UNITED STATES PATENT AND TRADEMARK OFFICE

APPLICATION NO.	FILING DATE	FIRST NAMED INVENTOR	ATTORNEY DOCKET NO.	CONFIRMATION NO.
10/733,539	12/11/2003	Timothy A. Tamcsin	20030317.ORI	2641
23595	7590	06/06/2005	EXAMINER	
NIKOLAI & MERSEREAU, P.A. 900 SECOND AVENUE SOUTH SUITE 820 MINNEAPOLIS, MN 55402			MILLS, DANIEL J	
			ART UNIT	PAPER NUMBER
			3679

Office Action Summary	Application No.	Applicant(s)	
	10/733,539	TAMCSIN, TIMOTHY A.	
	Examiner	Art Unit	
	Daniel J. Mills	3679

DETAILED ACTION***Drawings***

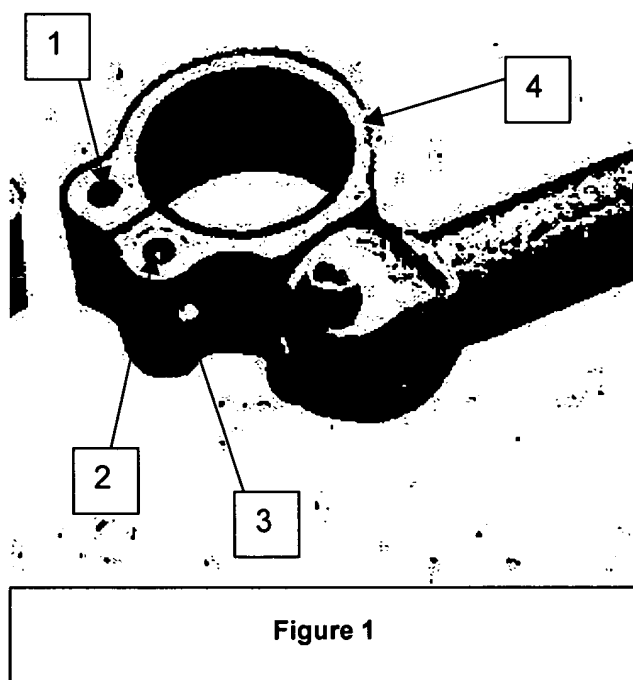
Twobros (see Figure 1 in this action) teaches a split ring clamping arrangement in which a locking portion integral with the split ring has a first post aperture (2) and a second post aperture (1), one on either side of a gap in the split ring, and a bolt aperture (shown by the positioning of bolt 3) through the locking portions, a first post having a smooth wall aperture there through and a second post having an aperture with a

threaded wall there through (this is clearly true from the illustration), and a bolt (3) for extending through the locking portion apertures and the posts for engaging the threads of the second post to adjust the size of gap between the locking portions. This arrangement is taught as useful to distribute the clamping load over the entire split ring. Accordingly it would have been obvious to one of ordinary skill in the adjustable handle bar clamp art at the time of applicant's invention, to modify an arrangement as disclosed by Kobacker to include a clamping arrangement as taught by twobros for the purpose of evenly distributing the clamping load.
